Building Permit Application

Permit No.: B18000437

Amendment Permit# B18000437
Address:
16463 Fredenck Rd

16463 Fredenck Rd to change the tank to
underground. Location stays the same.

STANLEY MILL PROPERTY
PLAT No. 3721
LOT No. 12

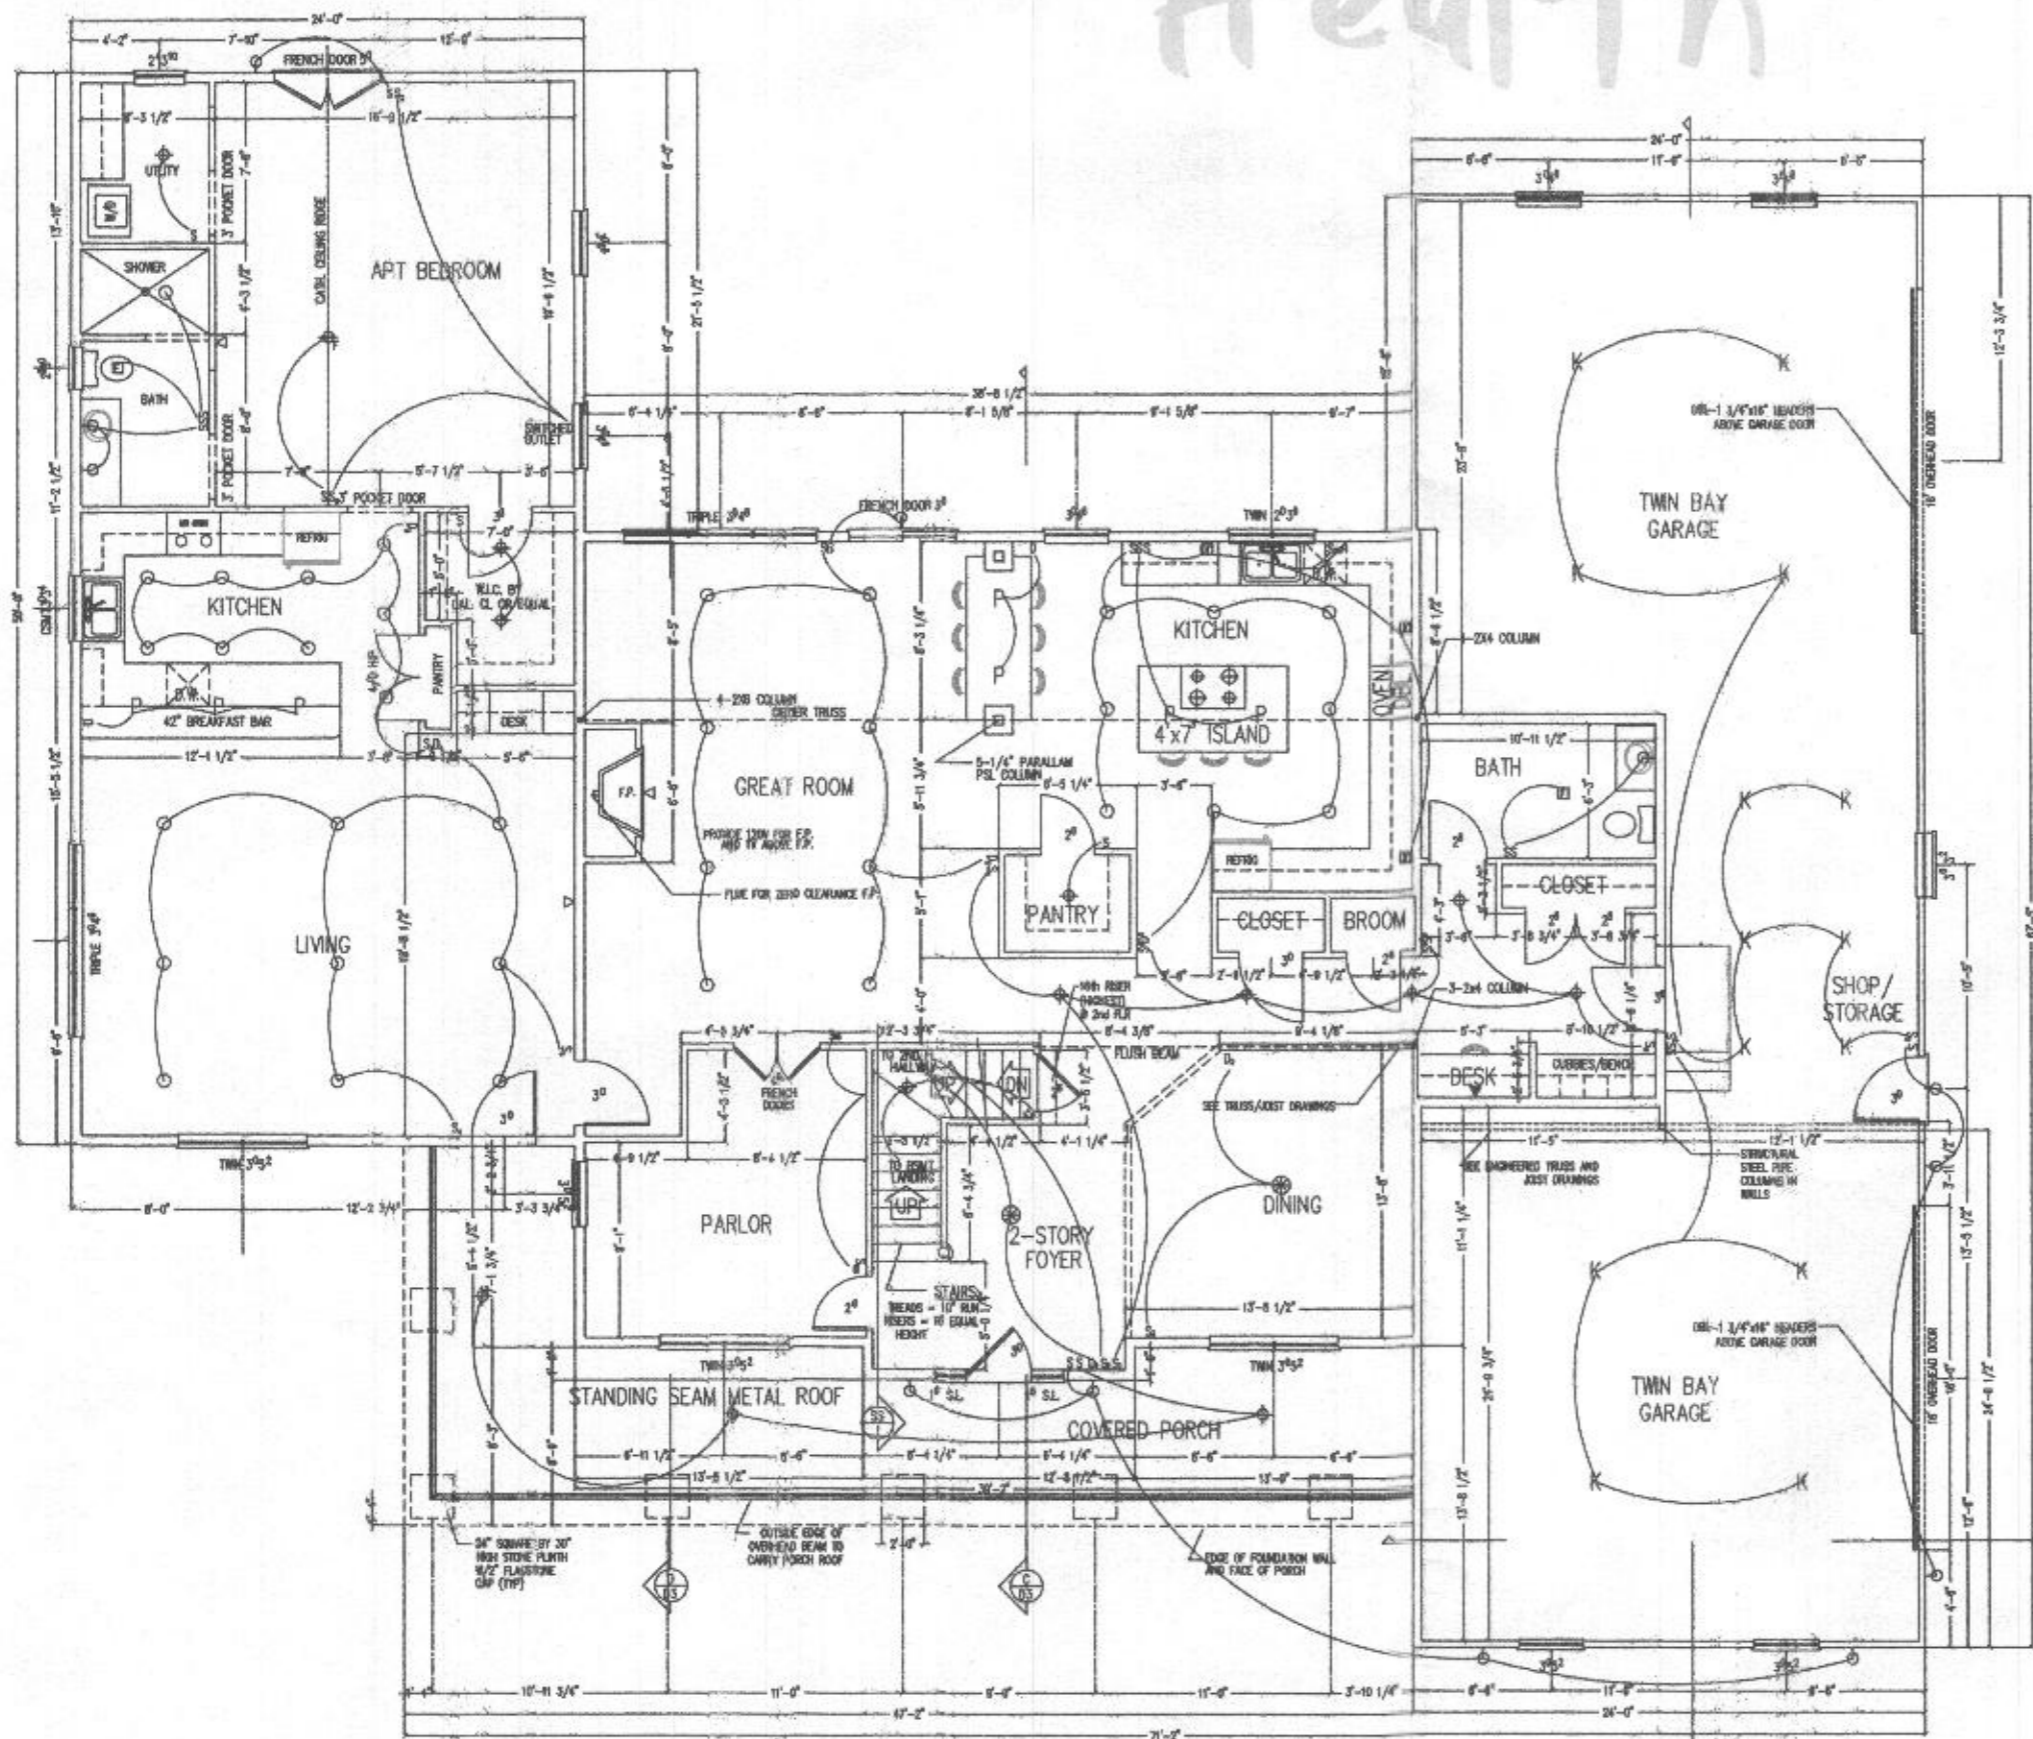
500 gal
above ground
Propane tank

Approved for
aboveground PT
B1800437
RMK
330.00'
2/16/18

BOROWY DECK DIMENSIONS

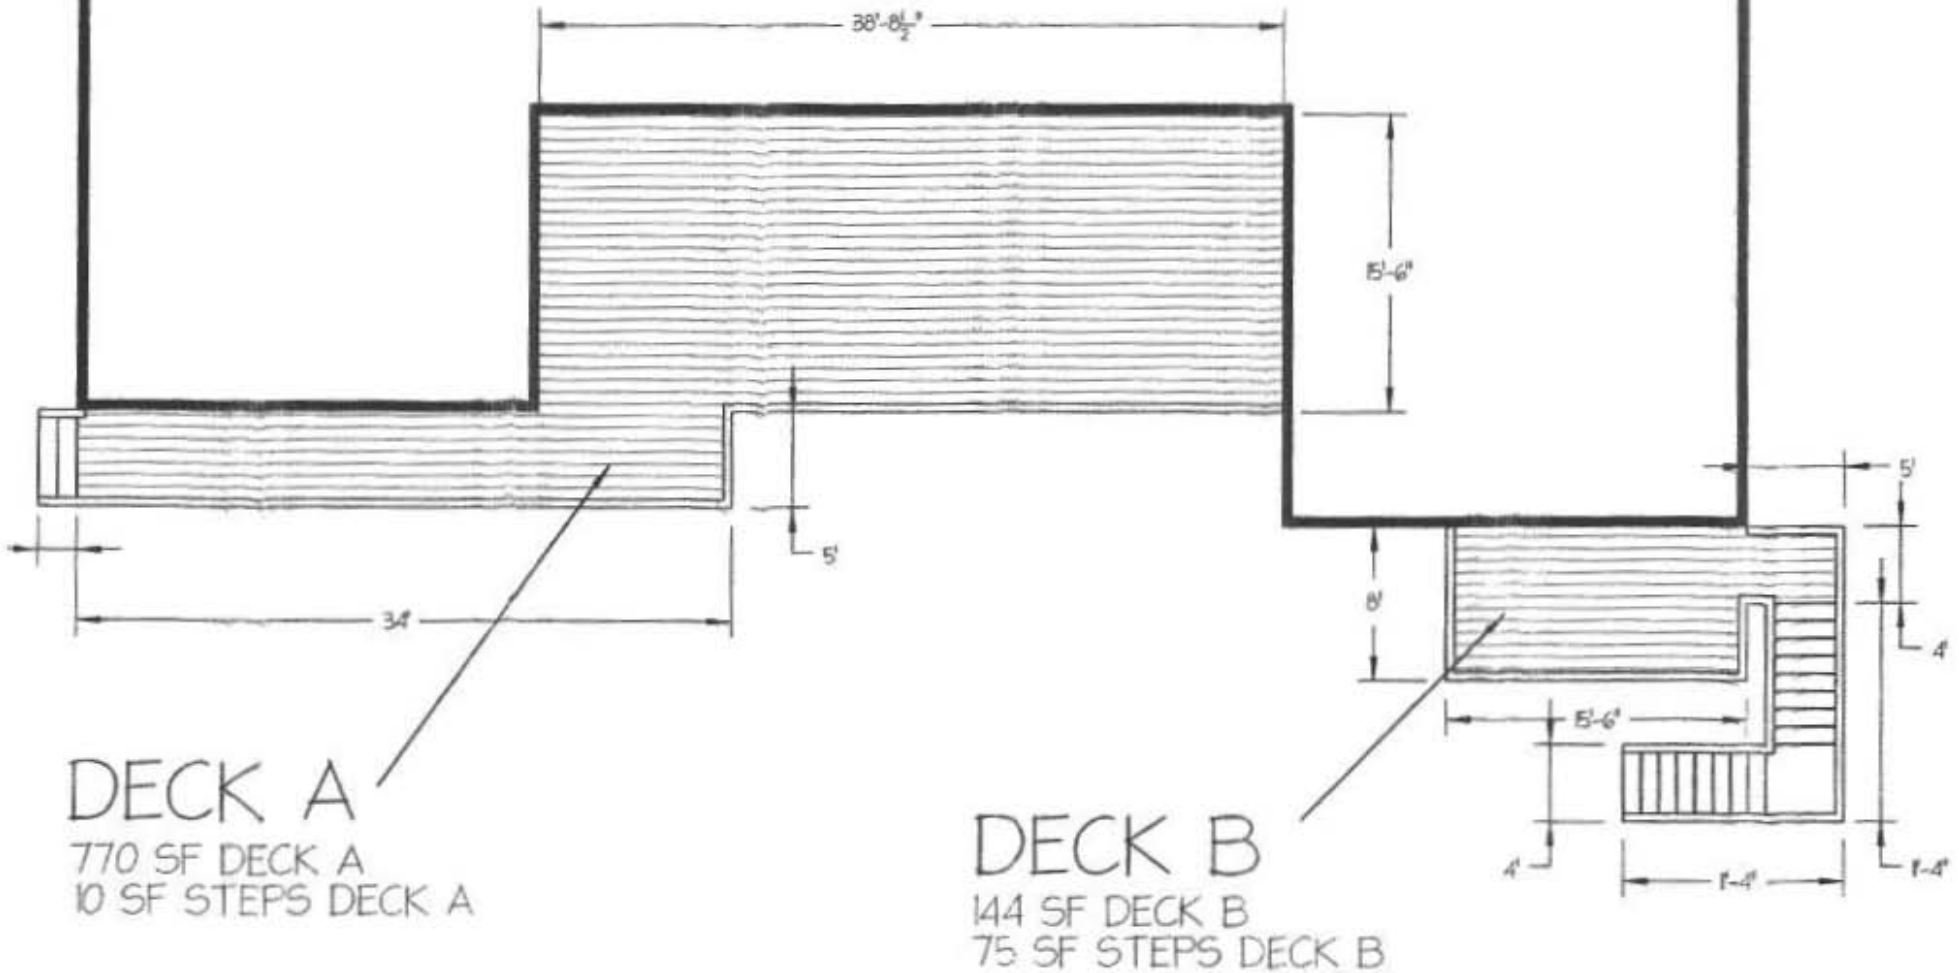
REVISED
 Date: 12-21-77
 Comments: add 2 decks

Deck 1: will be 8' x 15' 6"
with stairs.

Deck 2: will be 38' 8" by
15' 6" with stairs and
walkway.
